**DEFENSE NUCLEAR FACILITIES
SAFETY BOARD**

In September 2017, the Defense Nuclear Facilities Safety Board reviewed the special tooling program at the Pantex Plant. We identified five deficiencies within the special tooling program: (1) application of the *Special Tooling Design Manual*, (2) weld quality and application of non-destructive evaluation techniques, (3) pedigree of preventive maintenance and in-service inspection programs, (4) performance criteria within safety basis documentation, and (5) special tooling loading conditions. These deficiencies continue to exist within the special tooling program. Further information on each is provided in the enclosure.

Pantex Plant Special Tooling Program Review

Figure 1. *Cracked Safety Catches in the W76 Aft Disassembly Fixture, 076-2-0382 [26].*

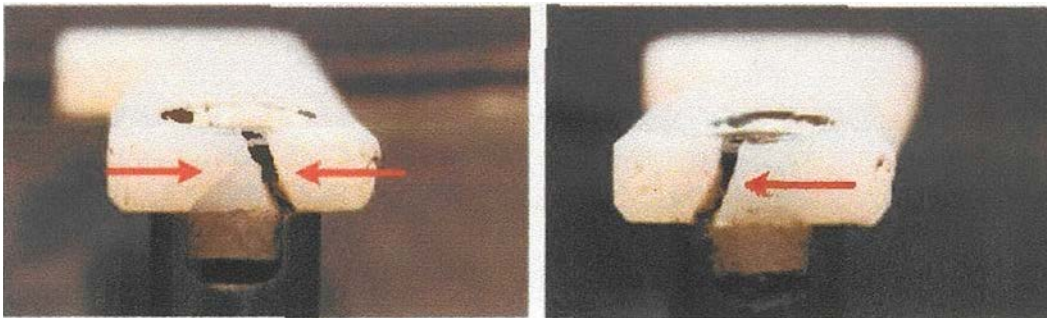
- *Safety Catches*—The staff review team evaluated the use of W76 vacuum lifting fixtures and the 2015 issue in which cracks were identified in vacuum lifting fixture safety catches (see Figure 1). The safety catches are a secondary feature to prevent a drop of high explosive charges should vacuum fail on the lifting fixture. The staff review team is concerned that actions taken to-date may not prevent recurrence of cracking of safety catches. Pantex continues to rely on production technicians to identify cracking during routine prior-to-use inspections. The staff review team believes that application of an ISI or introduction of a specific step within the nuclear explosive operating procedure to check for safety catch damage prior to use would bolster the reliability of this check. Alternatively, the safety catches could be redesigned, substituting a material with a lower likelihood of cracking (e.g., appropriately coated metal).
